## RESPONSE TO AN BORD PLEANÁLA OPINION

### Clonkeen Strategic Housing Development (SHD)

LANDS ADJOINING CLONKEEN COLLEGE, CLONKEEN ROAD,  
BLACKROCK, CO. DUBLIN

Ref: ABP-309039-20

Figure 3.2 – Extract of 21<sup>st</sup> March Shadow Diagram – School Pitches – Prepared by O' Connor Sutton Cronin Consulting Engineers [Cropped by TPA, 2021]

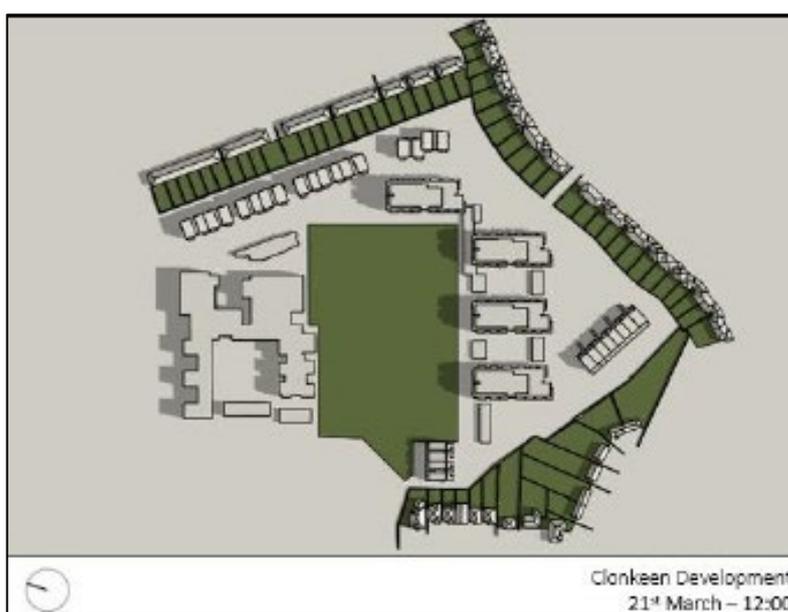
*“A report / analysis which specifically addresses Policy SIC8 (Schools) of the current development plan, including consideration of the impact of the proposed development on the function of the existing school campus and on the potential expansion of the existing schools. The report should also identify the demand for school places likely to be generated by the proposed development and the capacity of existing schools in the vicinity to cater for such demand.”*

We also note the enclosed *Daylight and Sunlight Analysis Report*, prepared by O' Connor Sutton Cronin Consulting Engineers, which confirms that there is an improvement on the sunlight levels to the adjacent playing pitches due to the revised scheme. An extract of these results, demonstrating the level of shadow cast onto the pitches on March 21<sup>st</sup> is included below.

Figure 3.3 Connection Plan to surrounding site areas and amenities, prepared by Doyle O’Troithigh Landscape Architects [Cropped and Annotated by TPA, 2021]

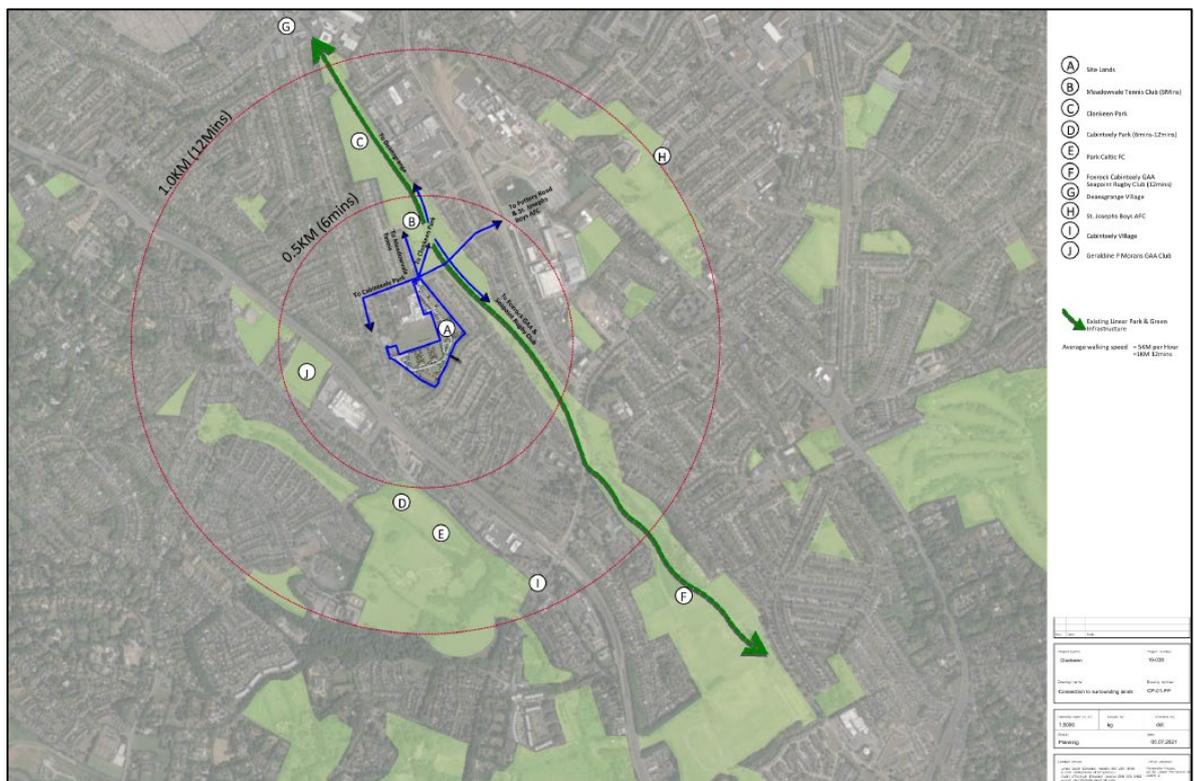
*“A report that address and provides a clear rationale for connectivity and permeability within and through the site.”*

***“In response to item 3 we have prepared a connectivity plan to illustrate connection to the surrounding amenities and through the site lands. As noted under item 3 The landscape plan has been revised to the eastern boundary to facilitate a potential connection to Monaloe Park Road. this is illustrated on LP-01-PP and LP-04-PP. See Appendix 1 for A3 images of both LP-01-PP and LP-04-PP.”*** [Our Emphasis]
